Woden Village DA RFI – List of Changes:

TYPICAL PRIVACY SCREEN DETAIL

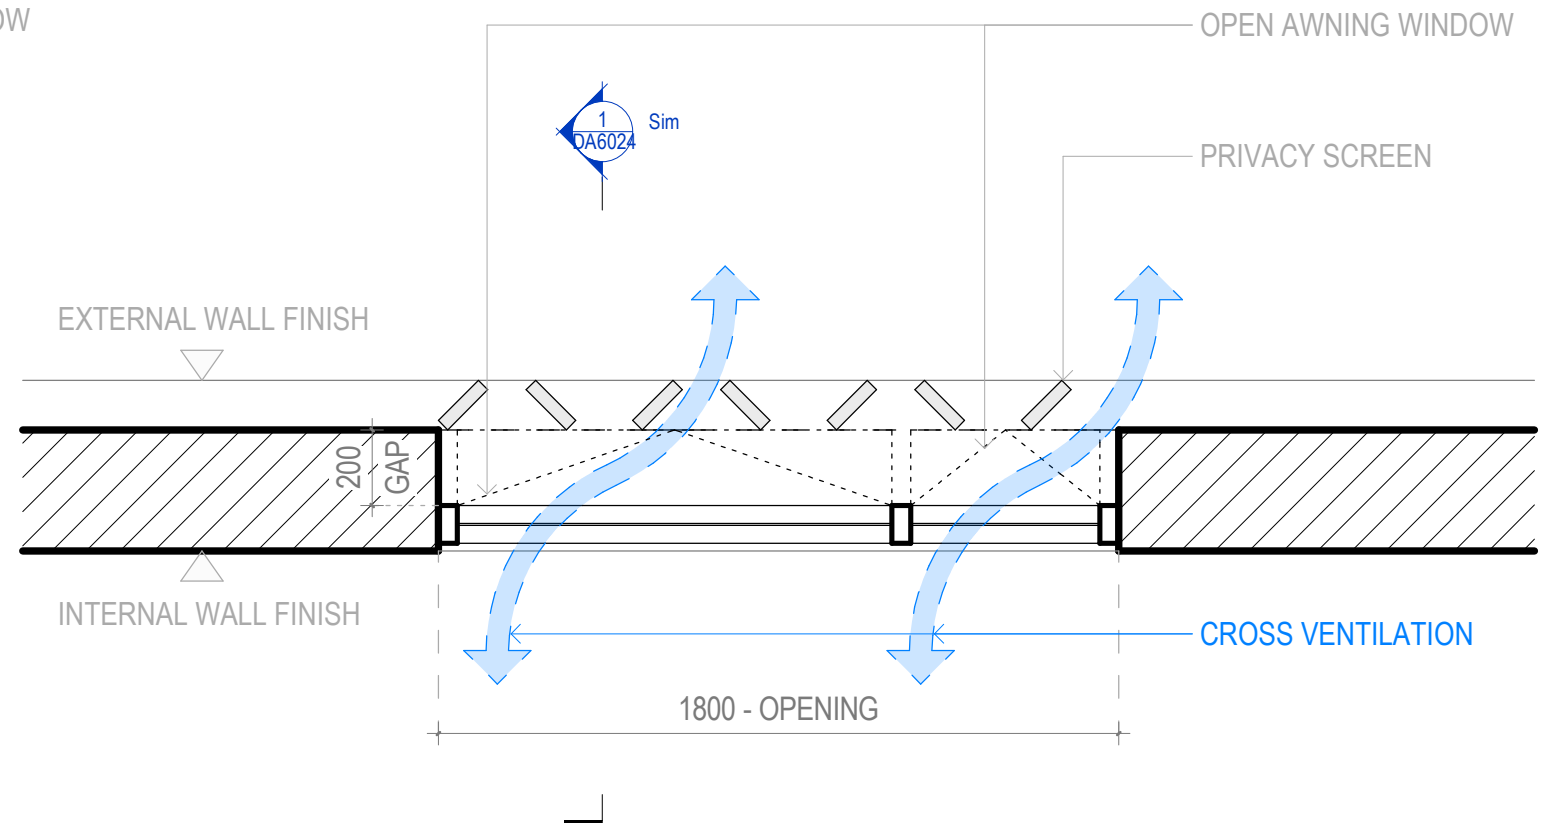
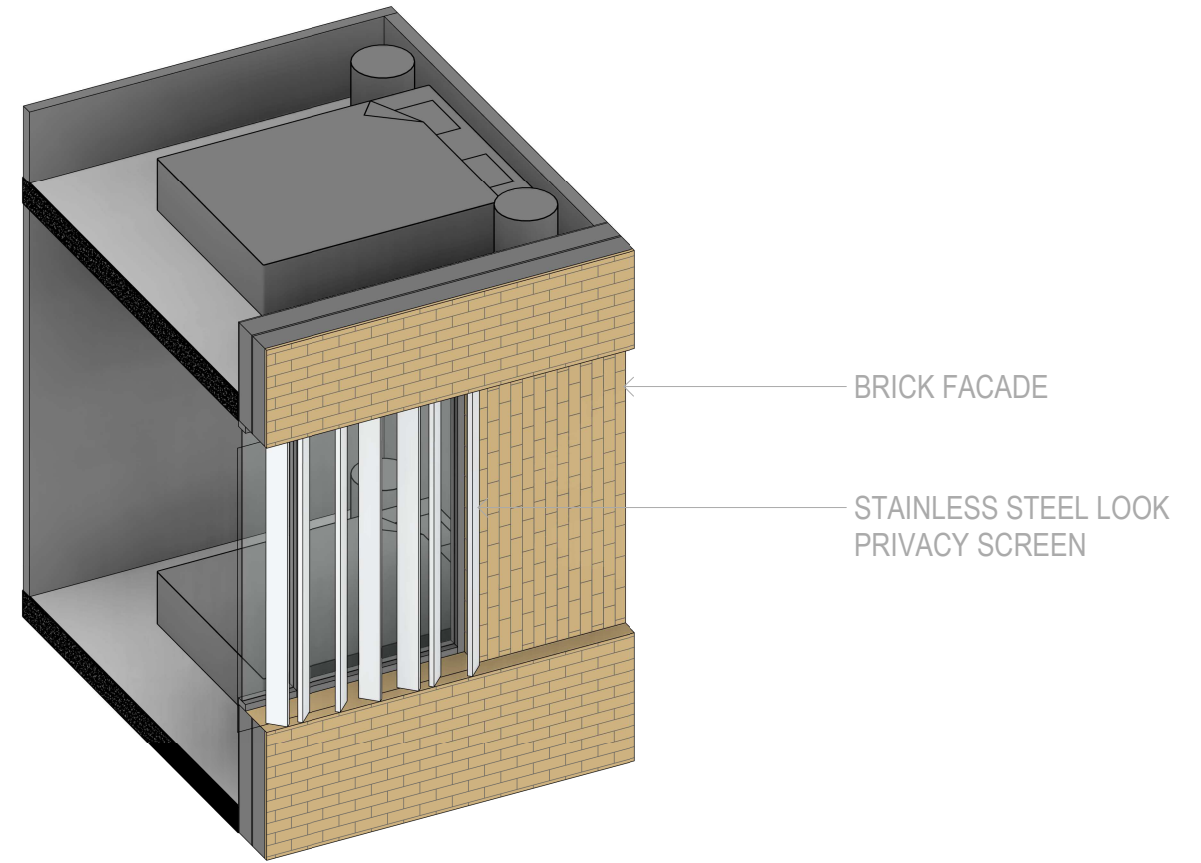
- A16.** Ground floor amenity space converted to a residential lobby.
- A17.** Privacy screen details provided.
- A18.** Additional elevations added.
